# 42 HONEYSUCKLE DRIVE COTTAGE CREEK PRECINCT NEWCASTLE

STATE SIGNIFICANT DEVELOPMENT (SSD-10378)  
DEVELOPMENT MODIFICATION 2

ARCHITECTURAL DESIGN STATEMENT

NOVEMBER 2021

# 3.3 DESIGN CHANGES THIRD FLOOR COMMERCIAL & HOTEL

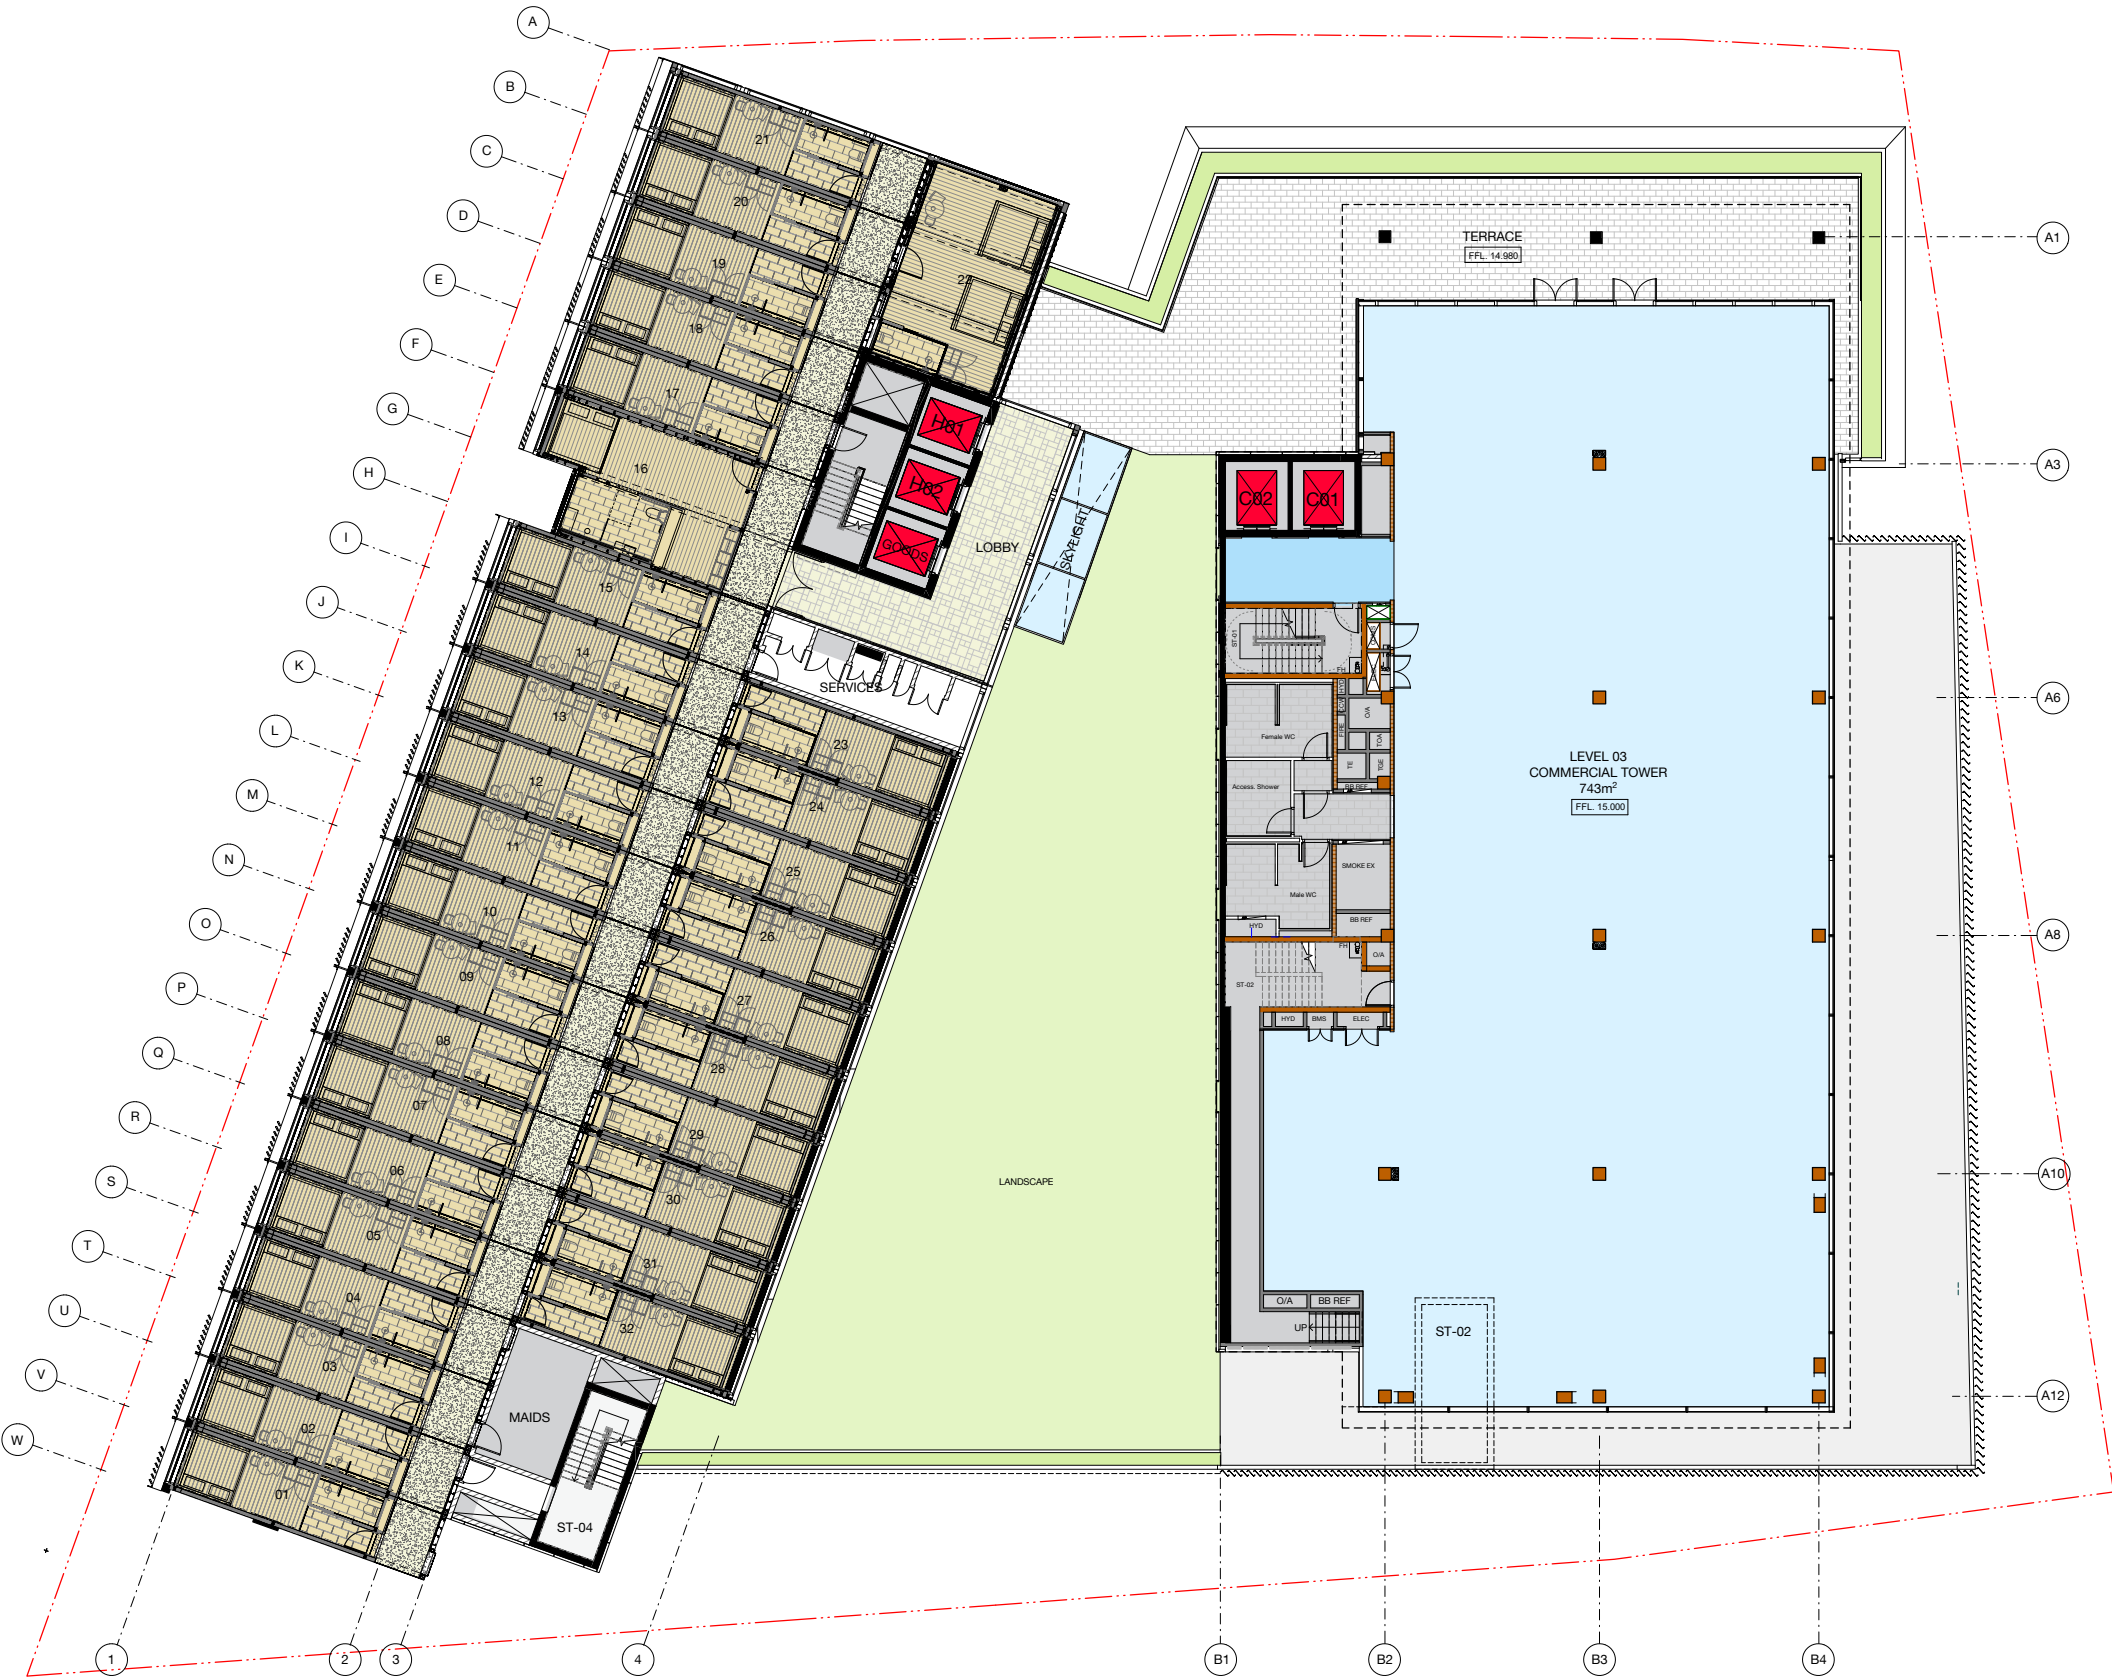
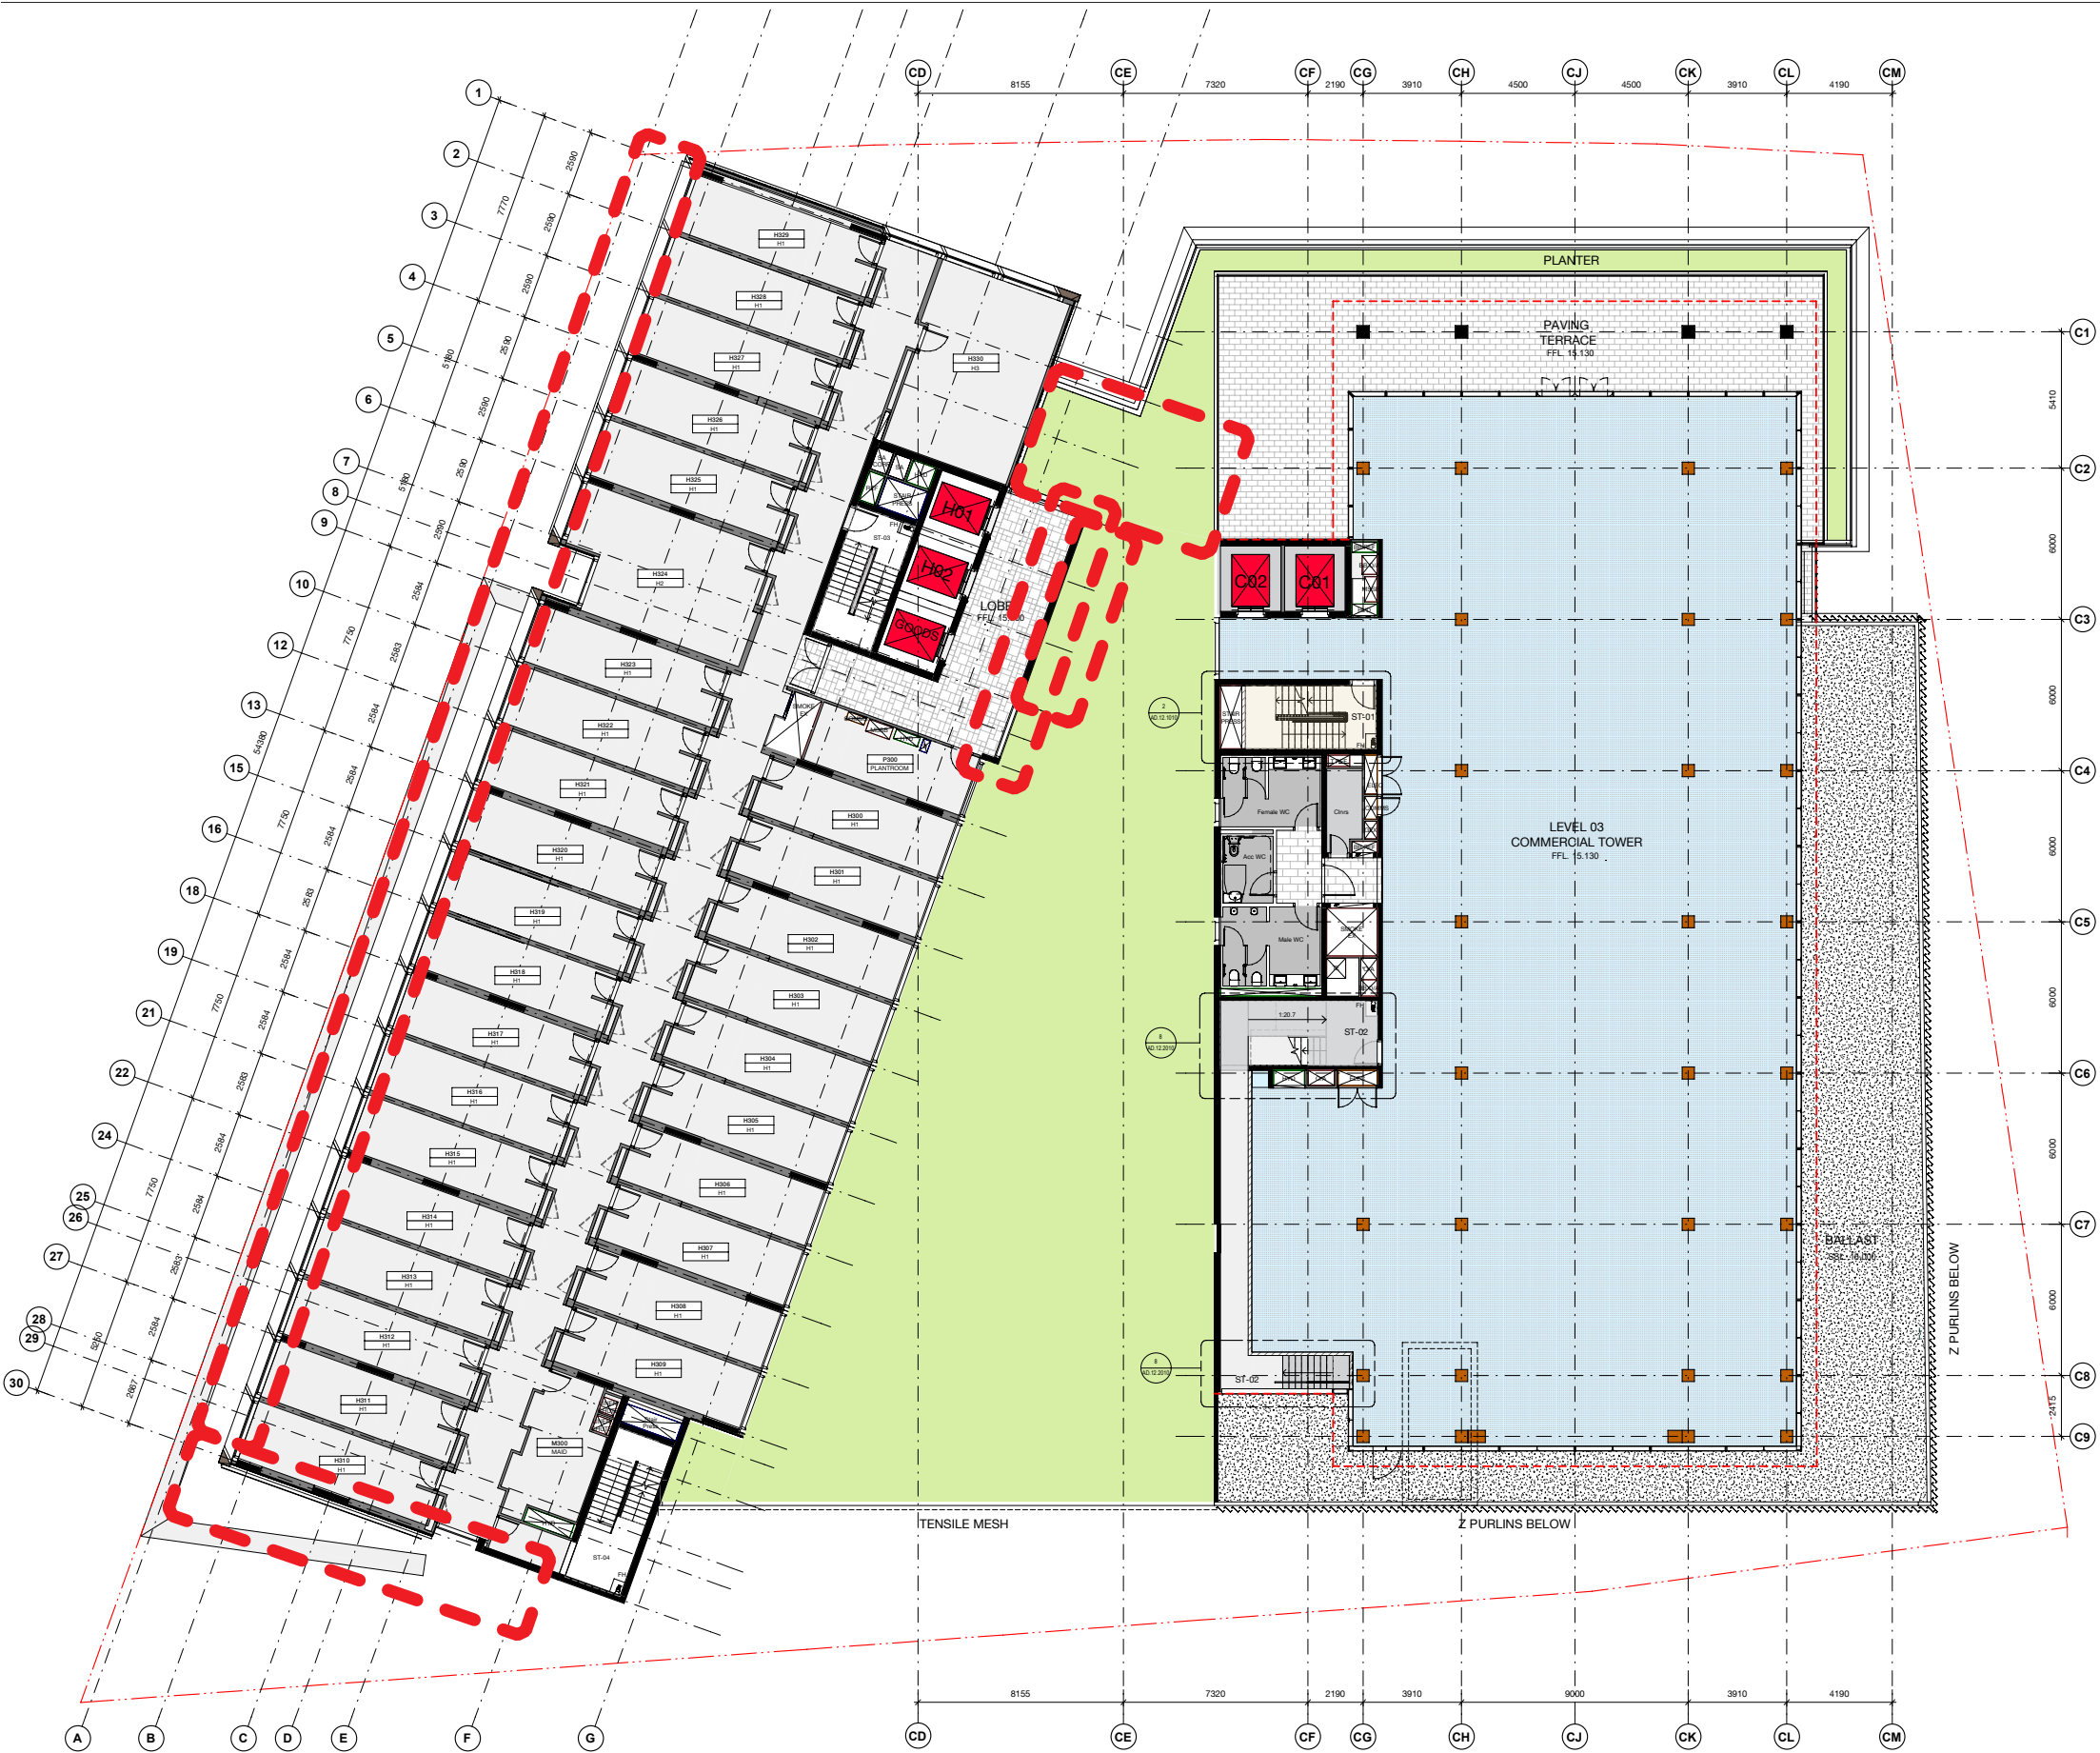
- 1 / South west end of the hotel - 1 room from every level omitted.
- 2 / Western hotel facade sunshading design amended
- 3 / Skylight over feature stairs below omitted.
- 4 / Landscaped area to the northern terrace increased.
- 5 / Hotel modular construction methodology amended to a traditional built form.
- 6 / Facade amended outside lift lobby. This is now concrete construction rather than glazing to increase privacy between the hotel and commercial tower.

# 4.1 DESIGN CHANGES FIFTH - SEVENTH FLOOR TYPICAL

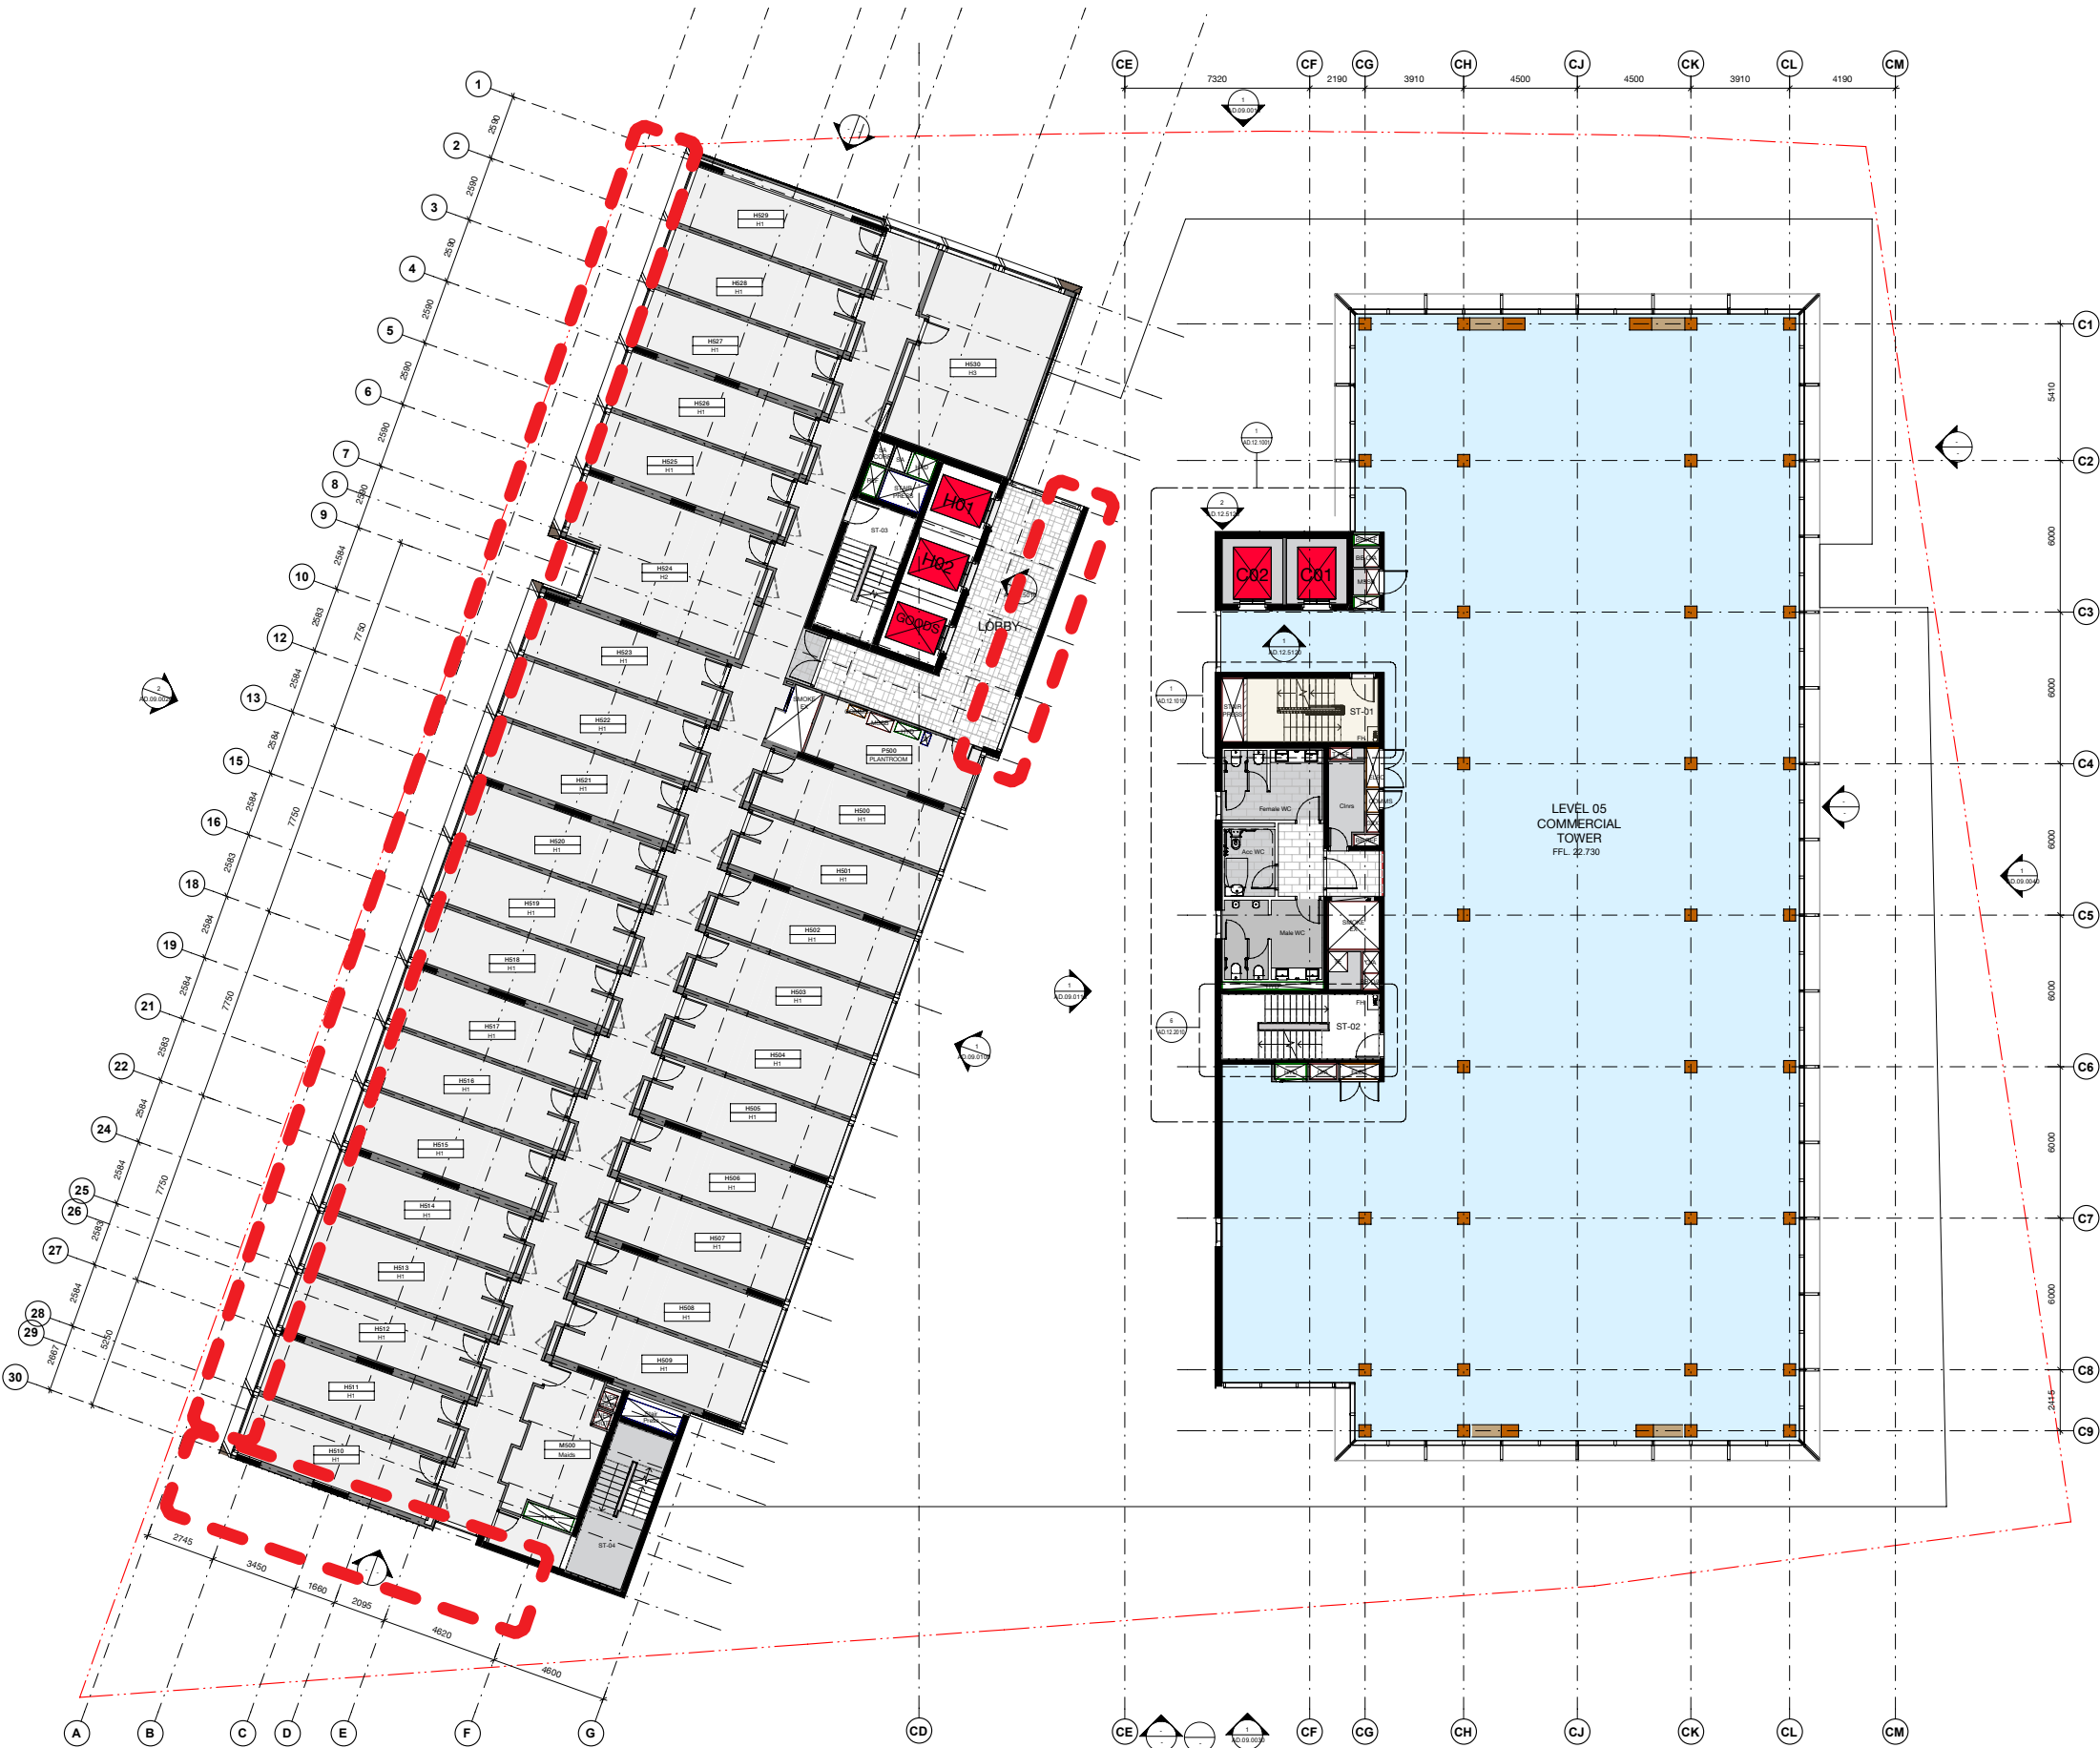
- 1 / South west end of the hotel - 1 room from every level omitted.
- 2 / Western hotel facade sunshading design amended
- 3 / Hotel modular construction methodology amended to a traditional built form.
- 4 / Facade amended outside lift lobby. This is now concrete construction rather than glazing to increase privacy between the hotel and commercial tower.
